Item Name: Lug

WORK ORDER NON-CONFORMANCE / UPDATE

DRAWING NO. D3394	TITLE LUG	REV. B	DART AEROSPACE LTD ENGINEERING ORDER		D.E.O. NO. D3394-B-1	SHEET NO. SHEET 1 OF 1	SCALE NTS
DRAWN AJS	CHECKED	MFG. APPR.	APPROVED		DE APPR.		
DATE 09.11.04	DATE 09.11.04	DATE 09-11-04	DATE 09/11/04		DATE 09/11/04

DRAWING NO. D3394	TITLE LUG	REV. B	DART AEROSPACE USA, INC ENGINEERING ORDER		D.E.O. NO. D3394-B-2	SHEET NO. SHEET 1 OF 1	SCALE NTS
DRAWN <i>JP</i>	CHECKED <i>Sc</i>	MFG. APPR. <i>M</i>	APPROVED <i>JP</i>		DE APPR. <i>JP</i>		
DATE 11.05.02	DATE 11.05.09	DATE 11.05.09	DATE 11.05.09		DATE 11.05.09

SHEET 4 ZONE A,1 MODIFY SECTION A-A AS SHOWN:

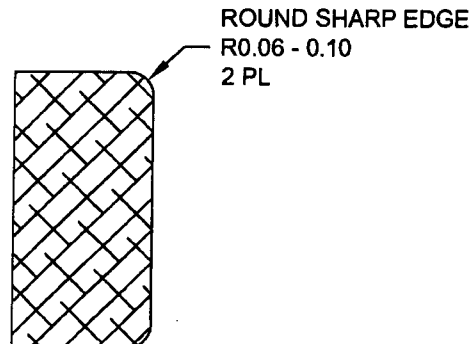
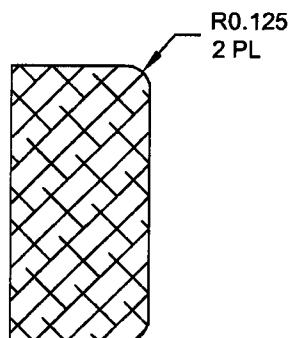
REASON: DRAFTING ERROR

IS:

WAS:

D3394-1RG LUG (SHOWN)
D3394-3RG/-5RG LUGS (SIMILAR)
D3394-041RG/-043RG/-045RG LUG ASSEMBLIES (SIMILAR)

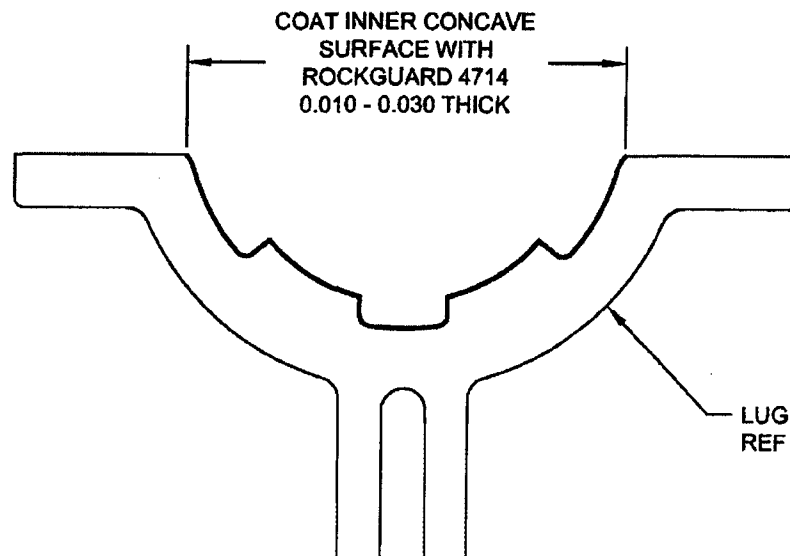
ADD D3394-xRG OPTION

D3394-xRG MOUNTING LUGS ARE INDENTICAL TO D3394-x MOUNTING LUGS, HOWEVER AFTER FINISH, COAT INNER CONCAVE SURFACE WITH "PLUS ONE ROCKGUARD 4714" AS SHOWN BELOW.
